**CITY OF MILL CREEK  
DESIGN REVIEW BOARD  
APPLICATION PL2020-0014**

**NAME OF PROJECT:** McDonald's Restaurant and Play Place

**PROPOSAL:** Proposed building elevations and landscaping

See excerpts below from **Attachment 1 – Full Site Plan Set** and **Attachment 2 - Existing Site Photo's** showing the existing site layout and the proposed new site layout.

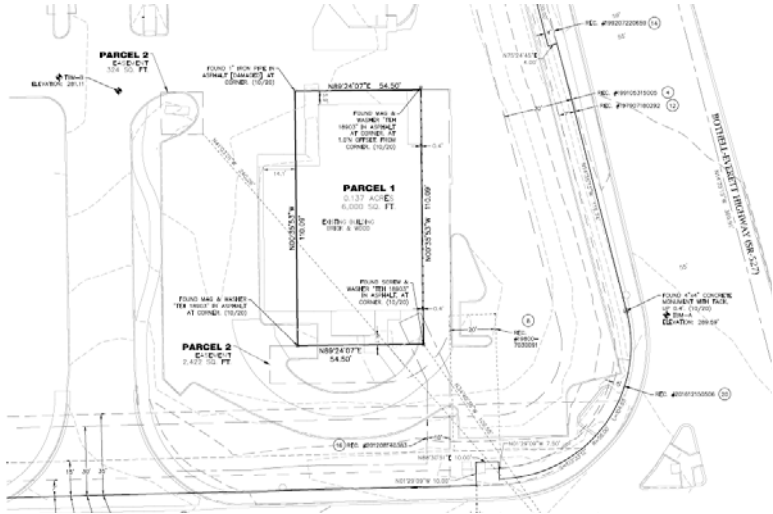
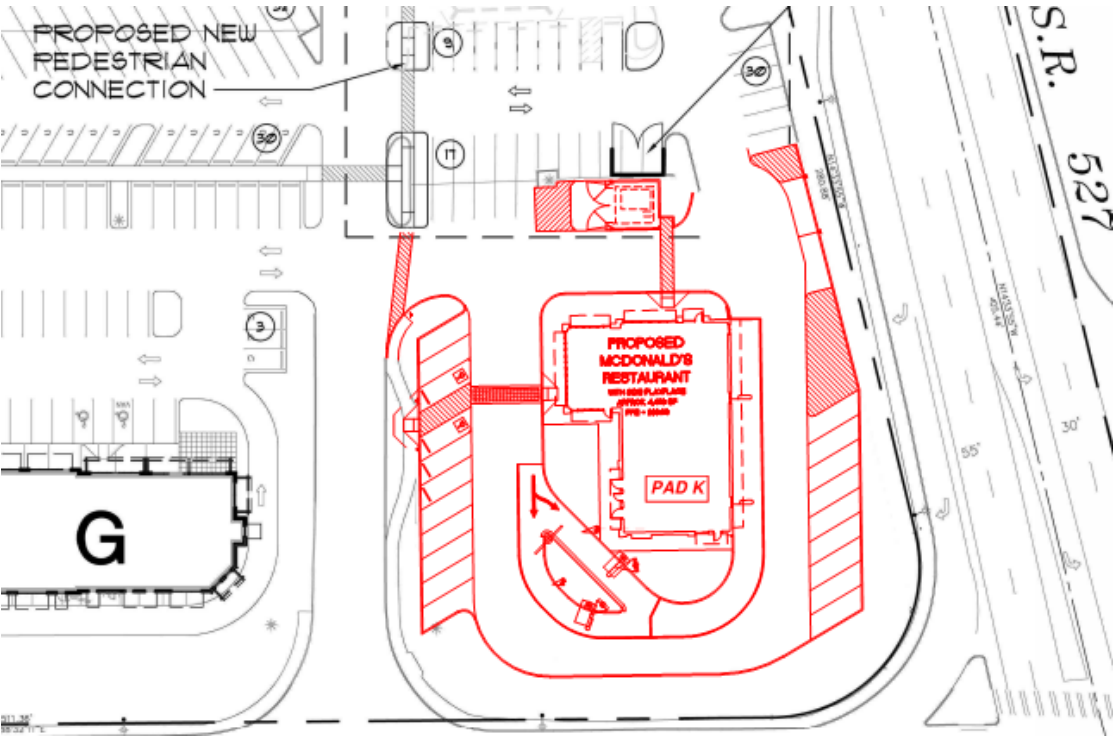
The applicant submitted a request for a Minor Modification to the Mill Creek Plaza Binding Site Plan, which was approved by the City on December 10, 2020. The applicant is proposing the demolition of the existing 5,549 square foot McDonalds Restaurant and Play Place, 50-stall paved parking lot, associated utilities and single-lane drive-thru, which was built in 1981. The construction of a new approximately 4,450 square foot McDonalds Restaurant and Play Place, 27-stall asphalt paved parking lot, dual-lane drive-thru, and associated underground utilities will occur on the 0.8 acre site. As part of the proposal, the applicant will be removing 851 square feet of roadway buffer and replacing with 1,246 square feet of roadway buffer.

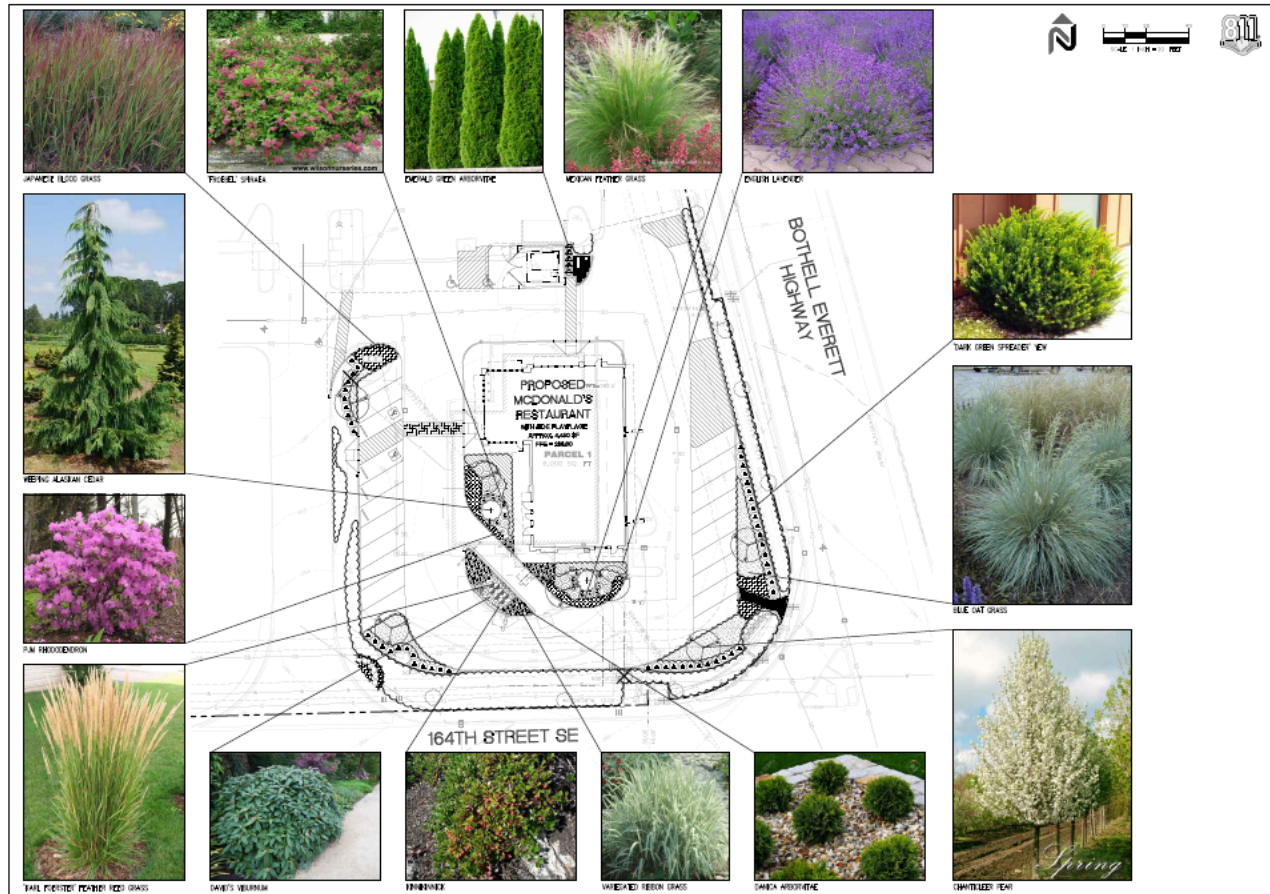
The proposed building elevations and exterior materials and colors add a variety of materials, textures, and colors to the new building. The concept is to modernize the restaurant to current corporate standards. Colors proposed are grey, black, brown, and yellow as an accent color with white canopies in material types comprised of concrete, metal and wood, which will meet the City’s design criteria. See **Attachment 1 – Full Site Plan, Sheet** for a depiction of the proposed exteriors. Materials proposed include:

Proposed materials will be arranged in horizontal bands of varying width and vertical patterns to help break up the building bulk and create prominent entry points. Windows and doors will be covered with white canopies to prevent roof run off dripping onto customers/employees, see **Attachment 1 – Full Plat Set (Sheets A2.0-A2.2)** for a full view of the elevations and details. The canopies are proposed to be lighted with LED lights to reduce glare and improve visibility for customers and provide safe access to pedestrians. The rooftop mechanical equipment is screened as shown in the elevations above to meet code.

As proposed staff believes that the building elevations and materials are in compliance with the design guidelines contained in the MCMC Chapter 17.34.

SHEET NUMBER  
**L-1.0**

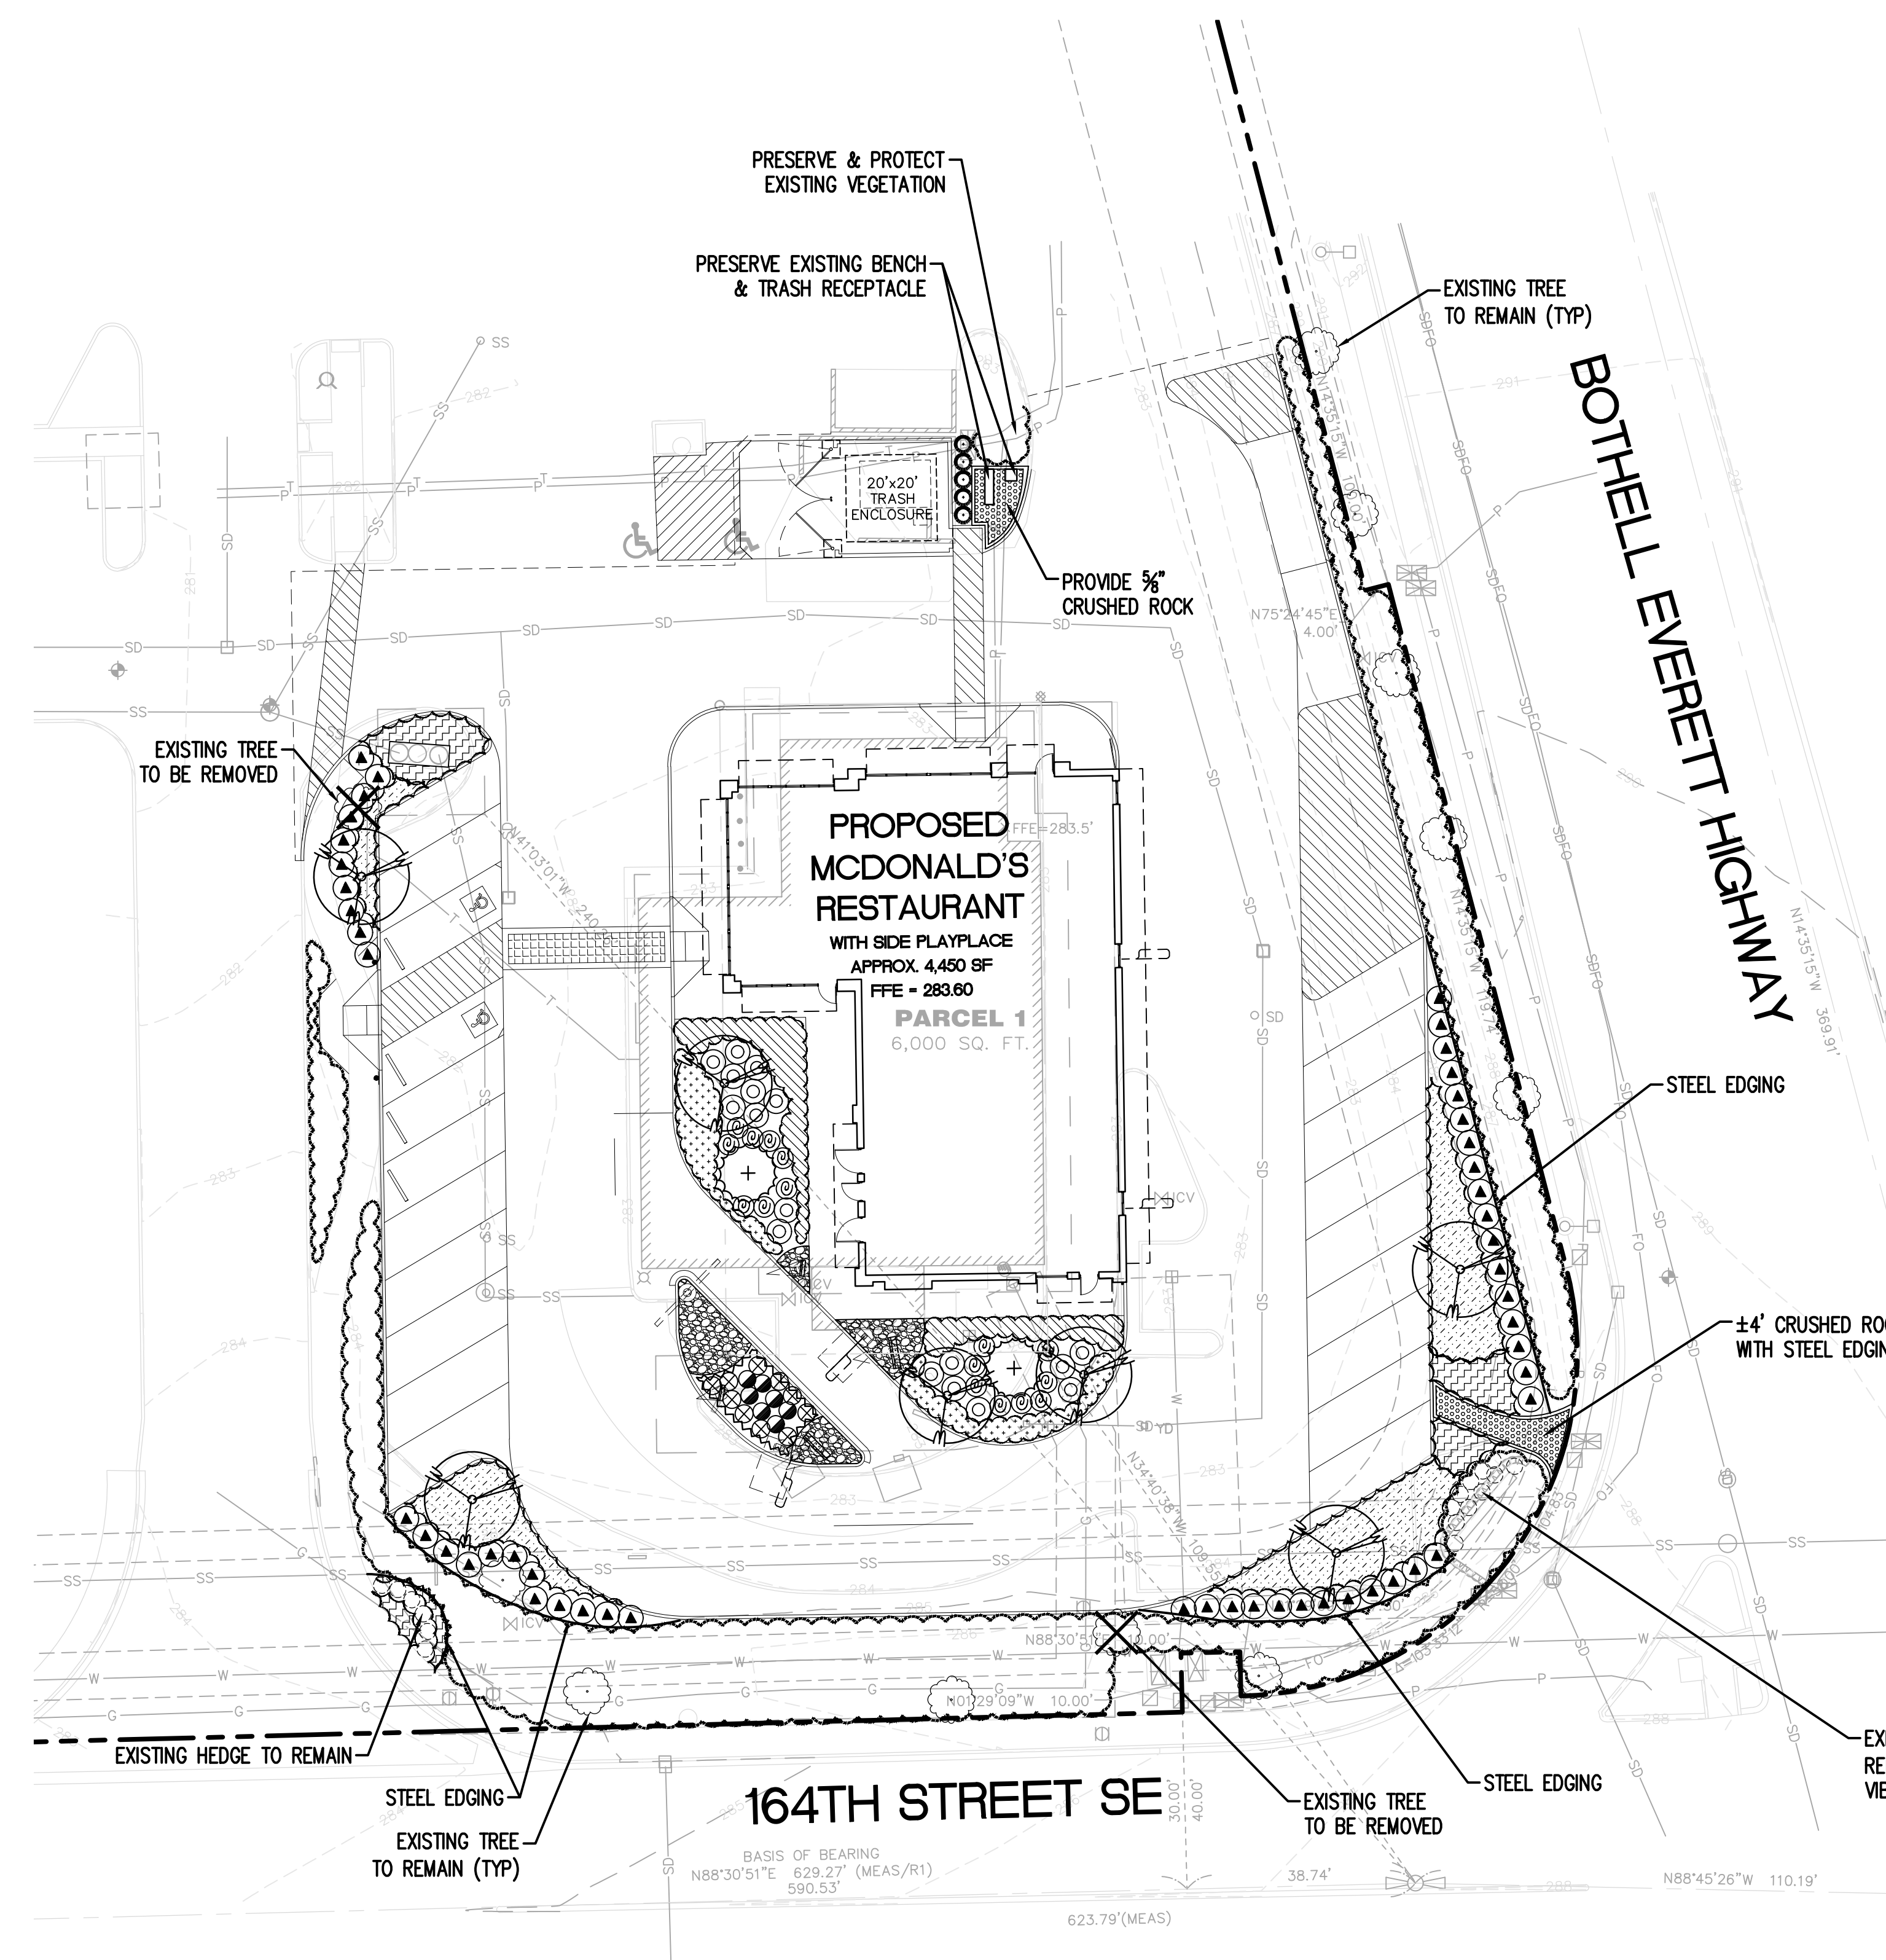
The applicant is proposing to modify the existing landscaping and enhance the existing plant palette by adding a vegetative barrier in the roadway buffer that is now primarily grass and at the entry into the site. Staff has included existing site photos below for your reference. The applicant has depicted on the landscape plan which existing landscaping is to be removed and what will be retained. See excerpts below and **Attachment 1 – Sheets C-1.1, L-1.0 and L-1.1. Landscape Plans and Plant Photos** along

The proposed plant palette consists of a variety of ornamental grasses, evergreen shrubs, flowering and evergreen trees and perennials in the required planting size and spacing requirements per code, see enlarged Planting Schedule below. In addition, the applicant is proposing steel edging along the landscape beds to separate between grass and graveled areas as necessary to provide for easier maintenance.

The Code requires landscaped areas to be irrigated, per MCMC Section 17.34.040.H.1.d and maintained by the property owner. The existing landscaping is irrigated and will be retained and maintained to water the enhanced (new) landscaping. Staff finds the proposed landscaping plan meets code and will enhance the overall appearance of the site and intersection.
